MEMORANDUM

To: Josh Arneson; Town of Richmond
From: Jason Charest, PE, PTP; CCRPC
Date: September 24, 2025
Re: Fay's Corner Safety Audit

Figure 5: Hinesburg Road northbound approach to Fay's Corner

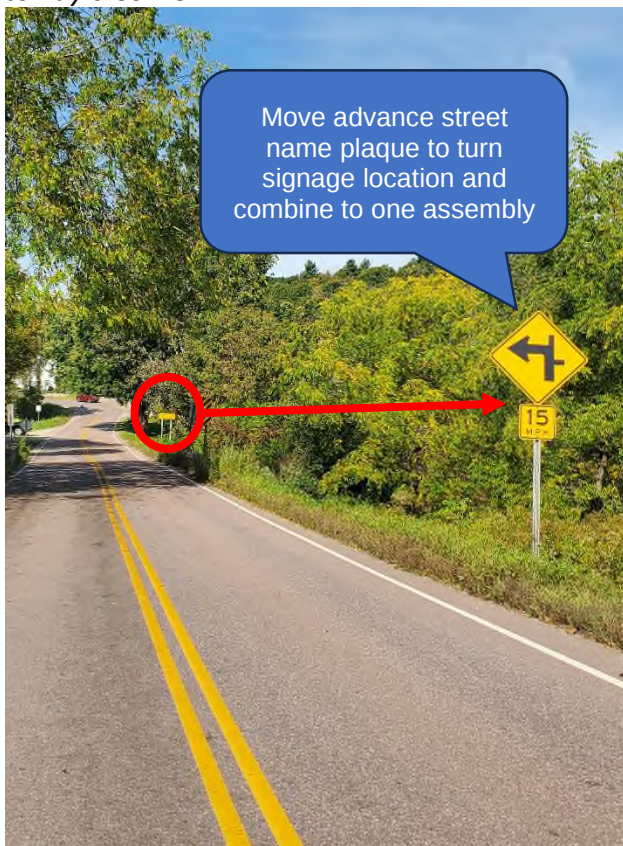
- The Hinesburg Road turn signage should be combined with the advance street name plaques on the westbound and northbound approaches to the intersection. For the westbound approach, the advance street name plaque should be relocated to the turn signage location to avoid being obstructed by the bridge object marker signage. For the northbound approach, the turn signage should be relocated to the street name plaque location as the turn signage is placed too far from the actual turn. (See Figures 4, 5, and 6)

Figure 9: Hinesburg Road northbound approach to Fay’s Corner

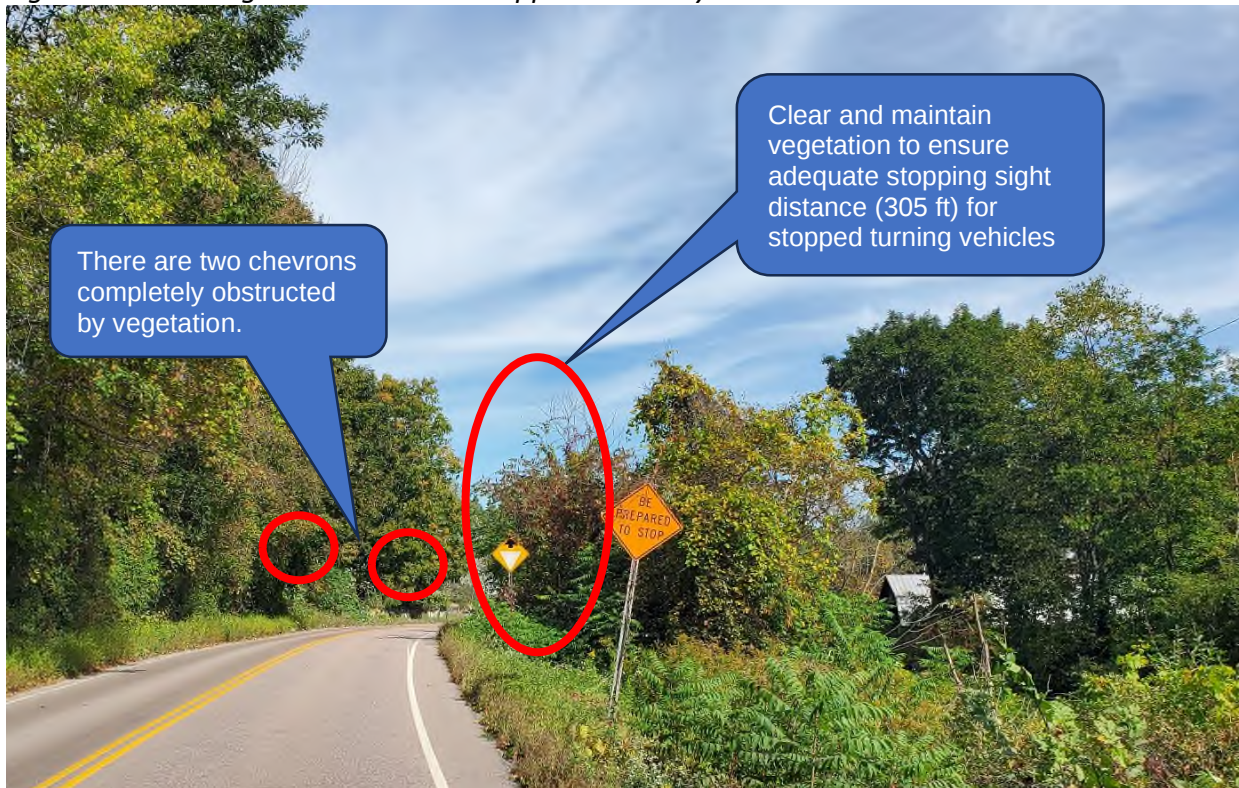
- The Hinesburg Road northbound chevrons are blocked by vegetation. Vegetation should be cut back and consideration to upsizing the chevrons could be given. They appear to be 18 x 24 inches and could go up a size to 24 x 30. (See Figure 9 below)

- There is overgrown vegetation that obstructs the inside of the Hinesburg Road curve on the northbound approach. This should be cut back and maintained to ensure a safe stopping sight distance (305 ft for 40 mph) around the curve should a vehicle be stopped to turn left onto East Hill Rd or Kenyon Rd. (See Figures 9 and 10)

- o Once the vegetation has been cut back, the northbound “Be Prepared to Stop” and “Crossing Traffic Yield to Right” signs can be removed and replaced with a new “YIELD” sign placed in line with the break in the centerline. The Yield Ahead sign may also be able to be removed depending on the “YIELD” sign’s visibility. The “YIELD” sign should be visible 305 feet in advance. If not, a new Yield Ahead sign should be placed around 300 feet in advance of the “YIELD” sign.

Figure 11: Traditional Two-Way Stop Controlled Intersection

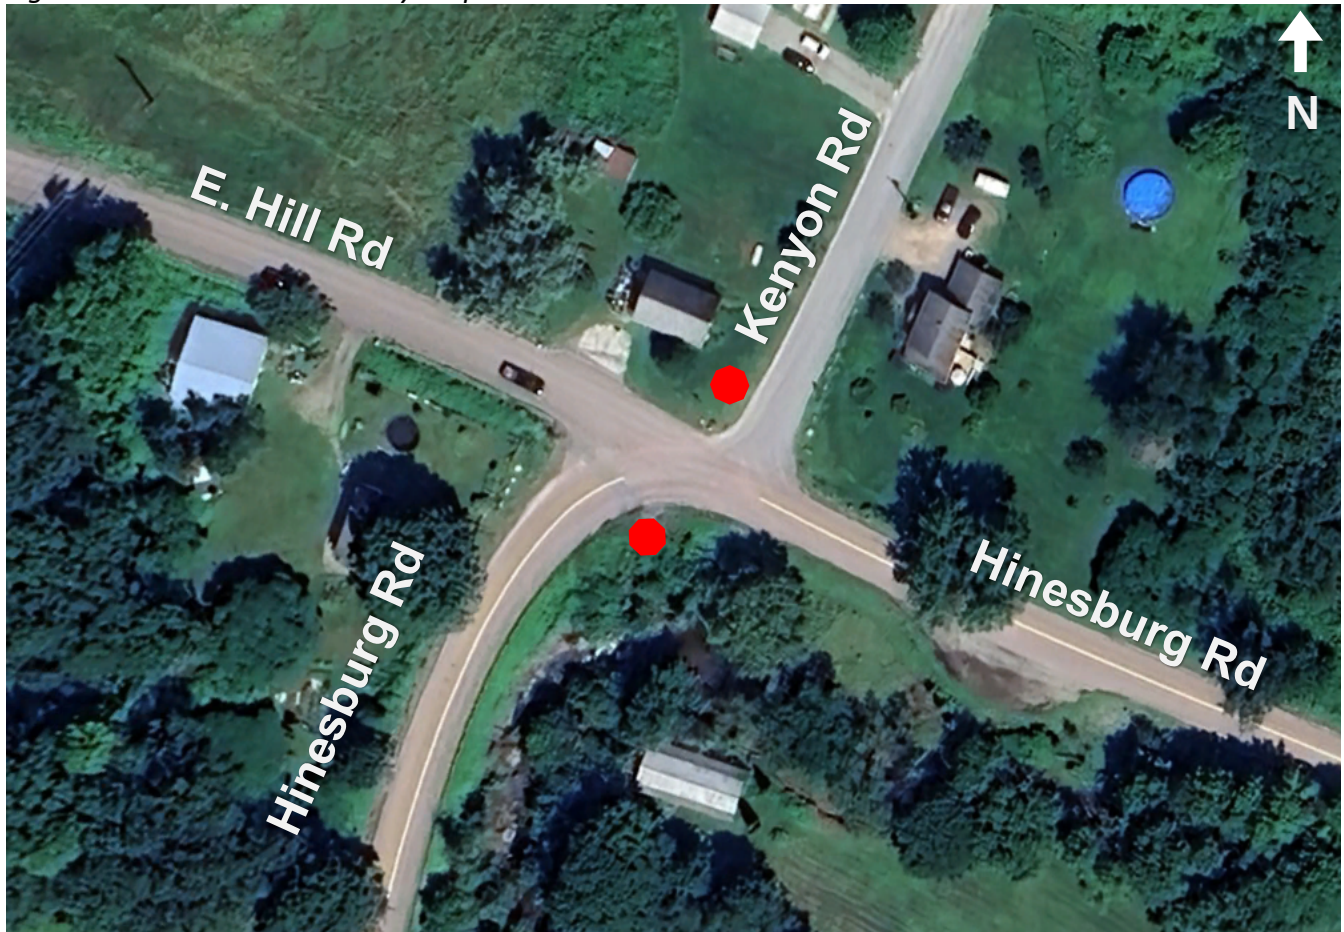
A traditional two-way stop control would move the STOP sign on East Hill Road to the northbound Hinesburg Road approach shown below in Figure 11. This would make East Hill Road and the westbound Hinesburg Road approach the uncontrolled through movement. The northbound Hinesburg Road approach would need to be realigned to square up with East Hill Road. Even then, it's unclear if vehicles newly stopped northbound on Hinesburg Road would be able to see an adequate distance up East Hill Road to make a safe maneuver. This could also create an additional hazard of East Hill Road traffic speeding through the intersection eastbound to Hinesburg Road given its steep downhill approach to the intersection. Interestingly, existing speeding through the intersection was observed in the opposite (westbound) direction during a follow-up site visit.

Of these two reconfiguration options, a traditional two-way stop controlled intersection is not recommended due to the safety concerns noted above. An all-way stop controlled intersection is, however, a viable option. It would not meet any traditional volume or crash experience warrants as outlined in the Manual on Uniform Traffic Control Devices (MUTCD), but the MUTCD allows for other factors to be considered in the installation of all-way stop control. Conflicting turning movements between northbound Hinesburg Road and Kenyon Road, and the intersection's unconventional stop control nature, could both be considered justifiable reasons for an all-way stop installation.

Figure 12: All-Way Stop Controlled Intersection

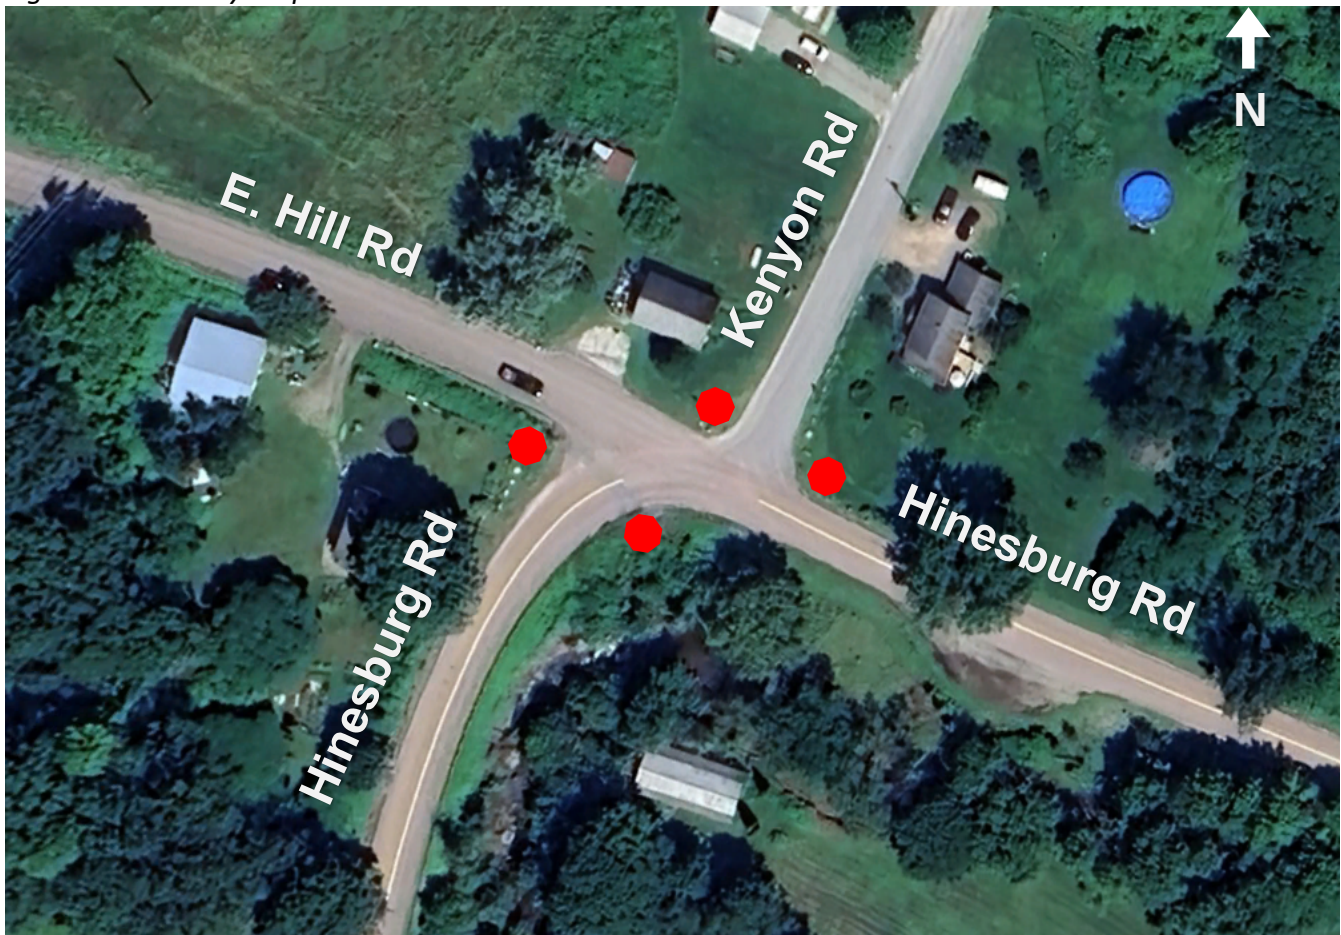
In an all-way stop control configuration, STOP signs would be added to the existing uncontrolled Hinesburg Road approaches shown in Figure 12 below along with accompanying supplemental signage and striping. Realigning the northbound Hinesburg and Kenyon Road approaches to a more traditional four-way intersection would be preferred in the longer term but not required in the immediate. Stop ahead signs would be recommended for the Hinesburg Road approaches along with an additional left-side STOP sign on the northbound Hinesburg Road approach to ensure visibility (unless the corner brush is sufficiently cleared out and maintained). Painting of stop lines would also be recommended. The other existing various signage could largely be removed.
